Access Compliance Report

Public Rights-of-Way

(Curb Ramps)

Intersection ID: 52582	Main Street: NOBLES_AV	Cross Street: N/A	Location: NE
ADA ID: 1C53B7AD27B6	Ramp Type: Perp	Initial Pass/Fail: Fail	Overall Compliance: No
Codes/Mitigation Info/Possible Solution		Field Measurements/Component Compliance	
Severity Score: 12.5

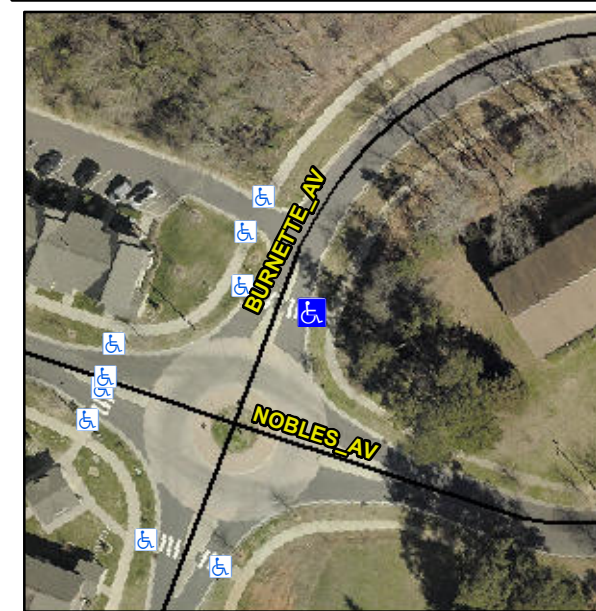
R304.2.2

Compliance	Description	Data	Compliance	Description	Data
N/A	Ramp Length (in)	73.0	No	Ramp Slope (%)	10.3
Yes	Ramp Width (in)	71.0	Yes	Ramp XSlope (%)	0.9
N/A	Flare Type LT	N/A	N/A	Flare Type RT	N/A
N/A	Flare Slope LT (%)	N/A	N/A	Flare Slope RT (%)	N/A
N/A	Flare Traversable LT?	N/A	N/A	Flare Traversable RT?	N/A
N/A	Landing Length (in)	N/A	N/A	DWS Provided?	N/A
N/A	Landing Width (in)	N/A	N/A	DWS Contrast?	N/A
N/A	Landing Slope (%)	N/A	N/A	DWS Length (in)	N/A
N/A	Landing X Slope (%)	N/A	N/A	DWS Full Width?	N/A
N/A	Landing Curb? (Y/N)	N/A	N/A	DWS Offset (in)	N/A
N/A	Shared Landing?	N/A			
N/A	Gutter Ponding?	N/A	N/A	Gutter Slope (%)	N/A
N/A	Gutter Lip Ht (in)	N/A	N/A	Gutter X Slope (%)	N/A
N/A	Painted X Walk1?	Yes	N/A	Painted X Walk2?	N/A
	X Walk 1 Direction	To NW		X Walk 2 Direction	N/A
N/A	X Walk 1 Width (in)	120.0	N/A	X Walk 2 Width (in)	N/A
	X Walk 1 Slope (%)	2.0		X Walk 2 Slope (%)	N/A
	X Walk 1 X Slope (%)	0.9		X Walk 2 X Slope (%)	N/A

Remove & Replace Entire Ramp.
